REZONING & CONDITIONAL USE PERMIT (CUP) APPLICATIONS & SITE PLAN REVIEW

12/14/20 Plan Commission Meeting

Taco Bell Restaurant / Sundance Inc.

Village Planner Report

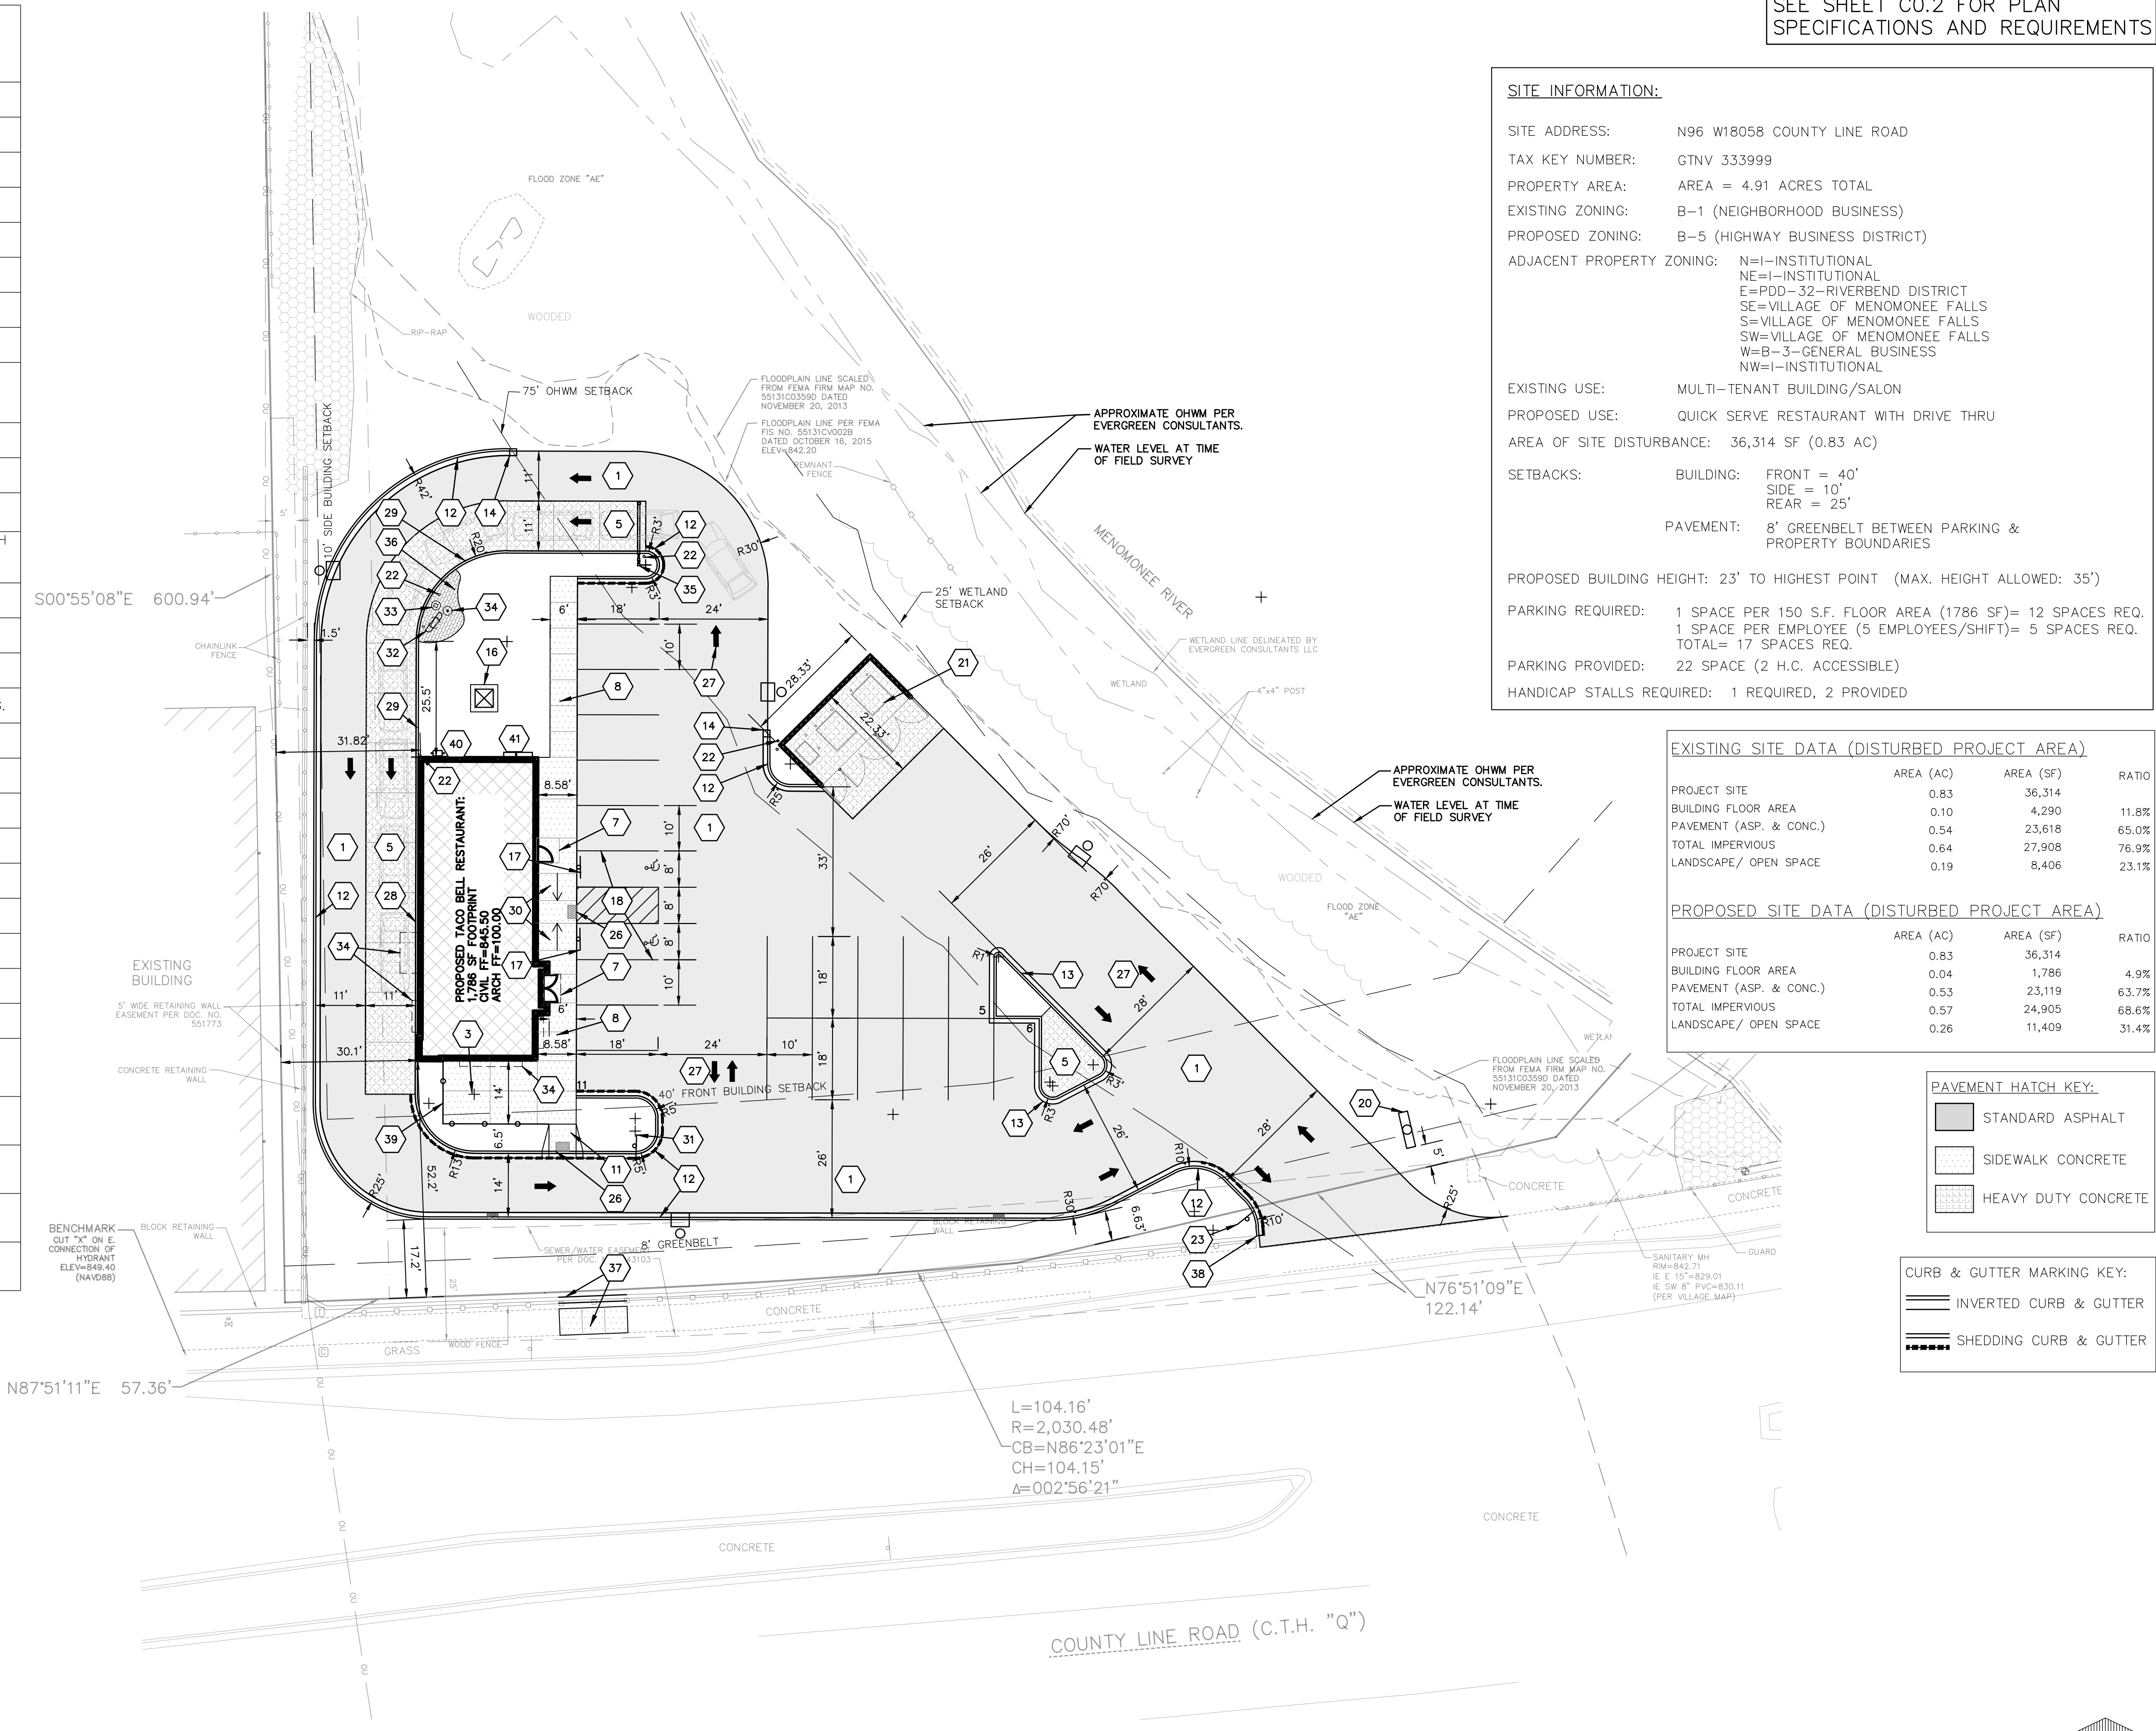
- 1 Provide an accessible route to the public sidewalk.
2. Driveway to the site provides for difficult ingress and egress with minimal throat length and stacking distance. Any other alternatives to improve this condition?

SHEET NUMBER
C1.2

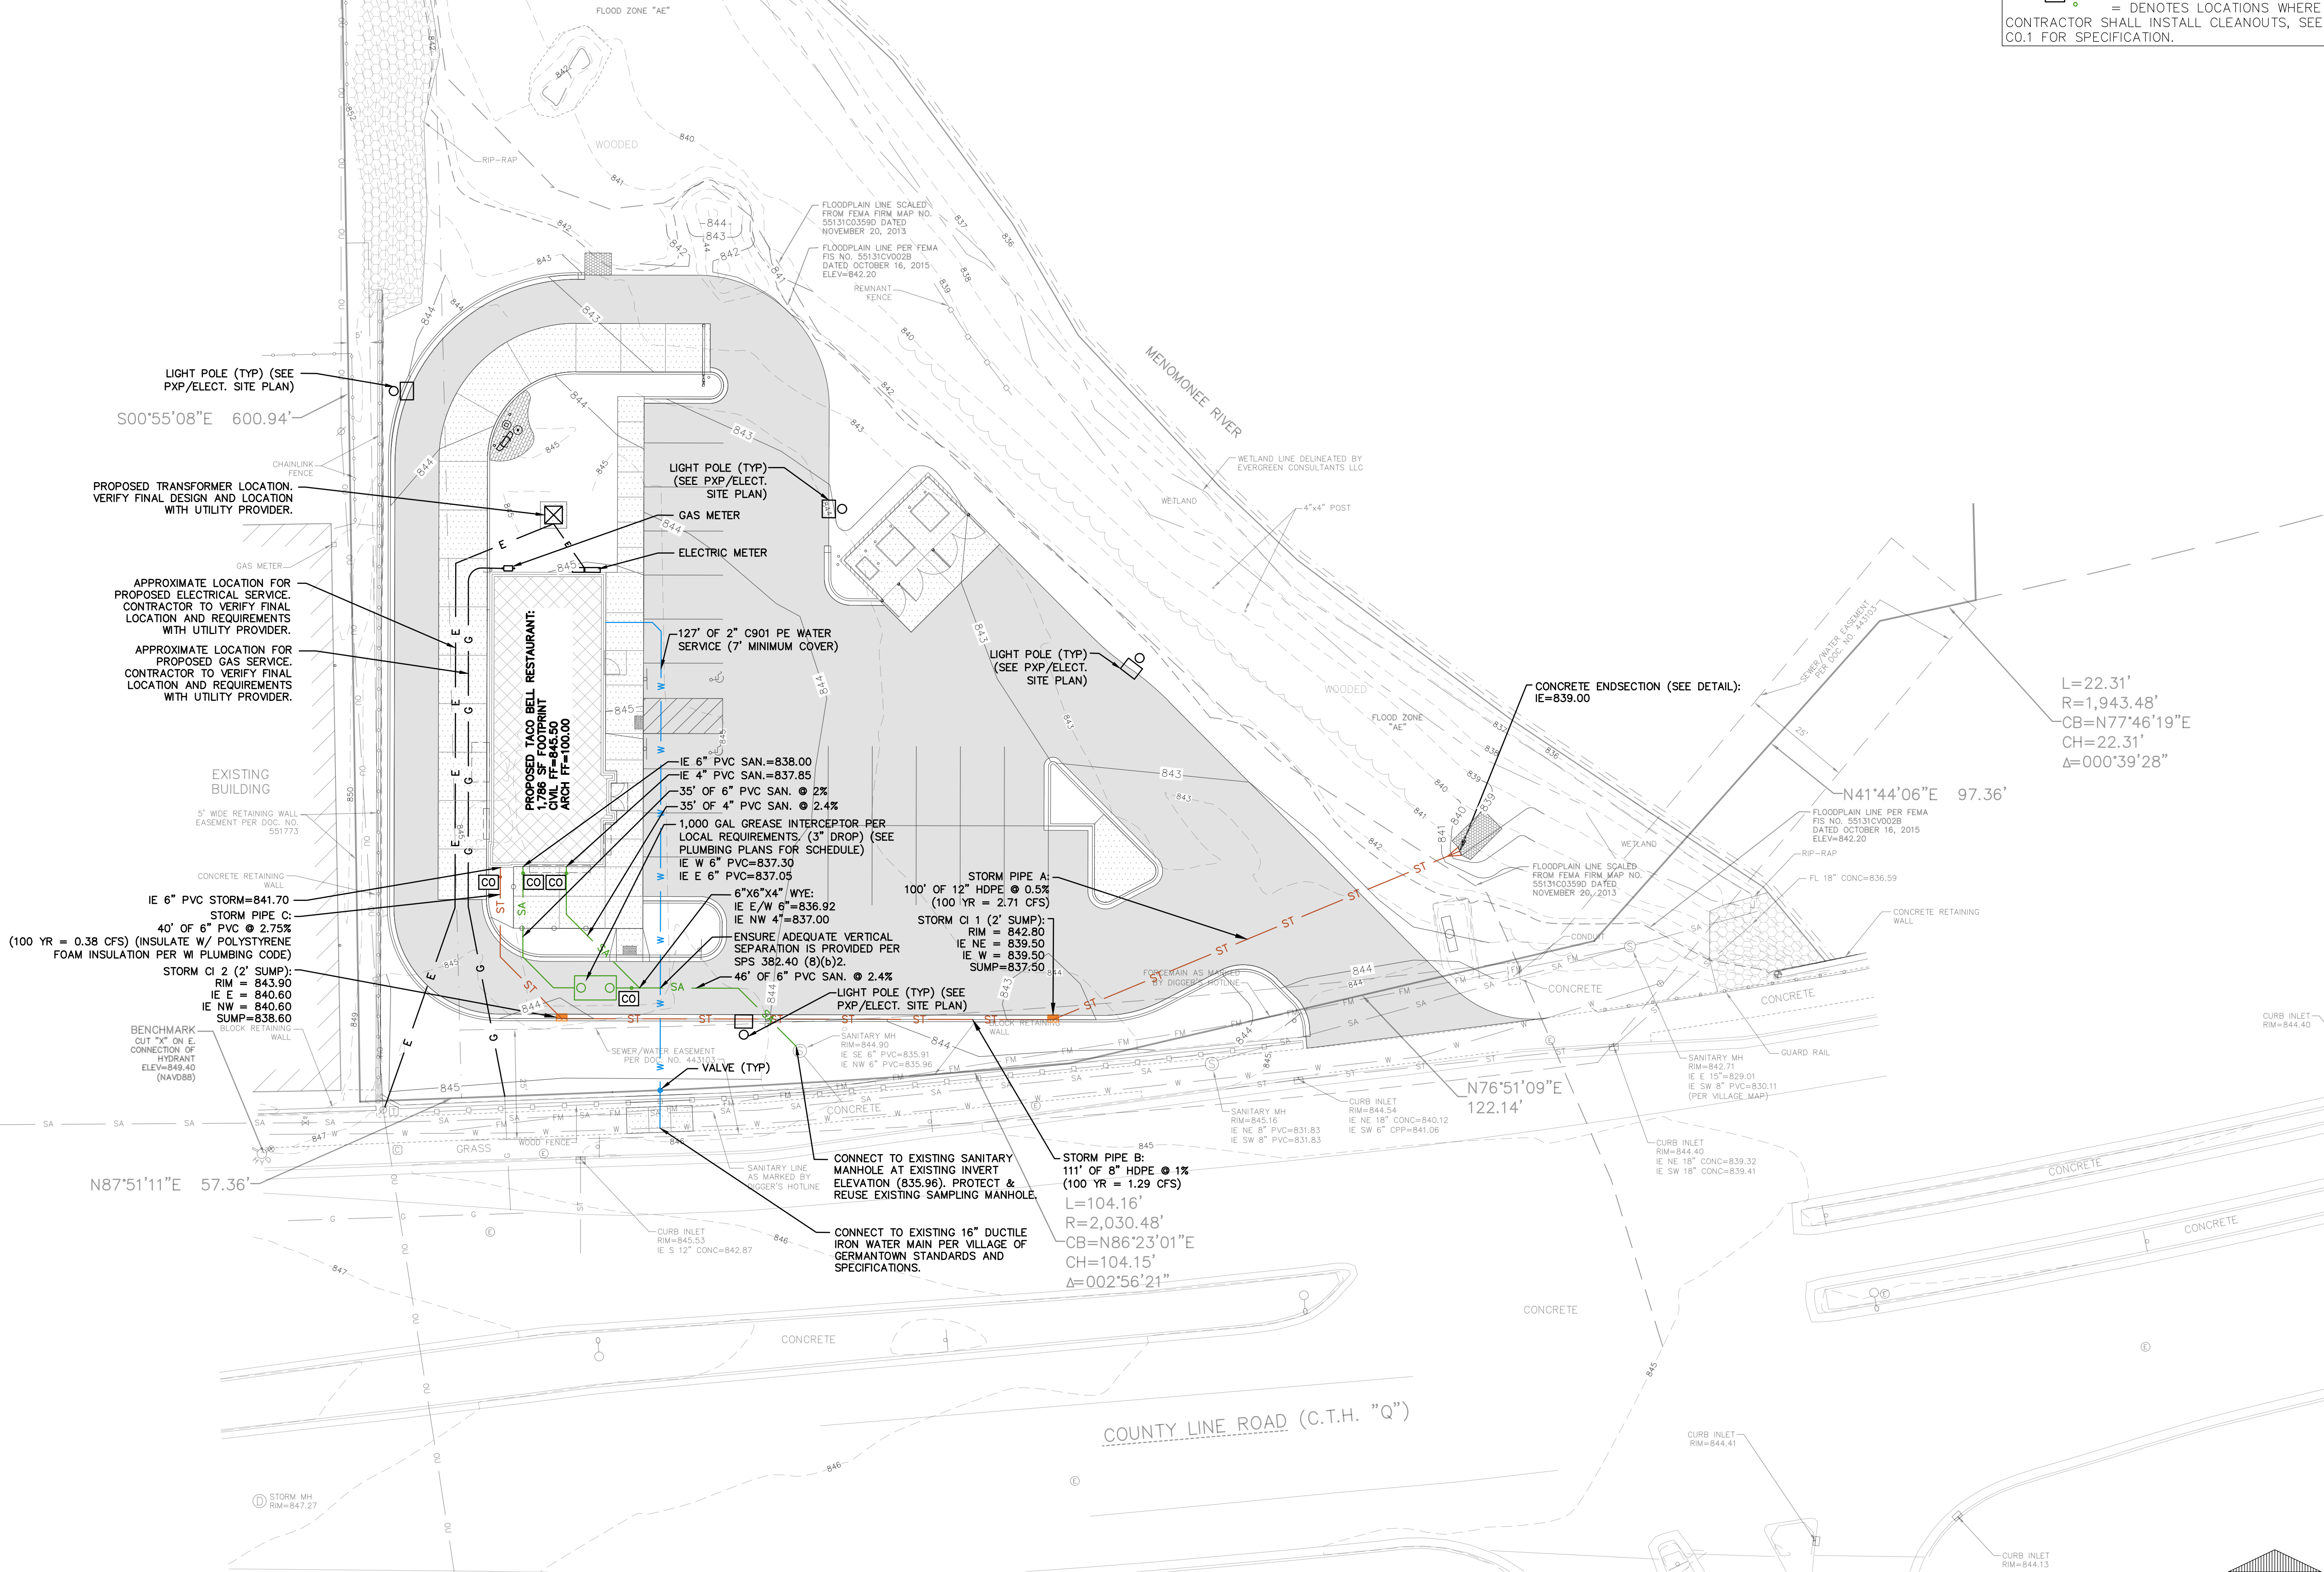
- 1 Show construction entrance location
2. Provide erosion control notes. Sequence, inspection requirements, stabilization timeframes, late season stabilization requirements, etc.
3. Silt fence does not work well for erosion control at pipe outlets. Provide alternate erosion control method at the storm sewer outfall. Show silt fence in a "U" shape to contain sediment.
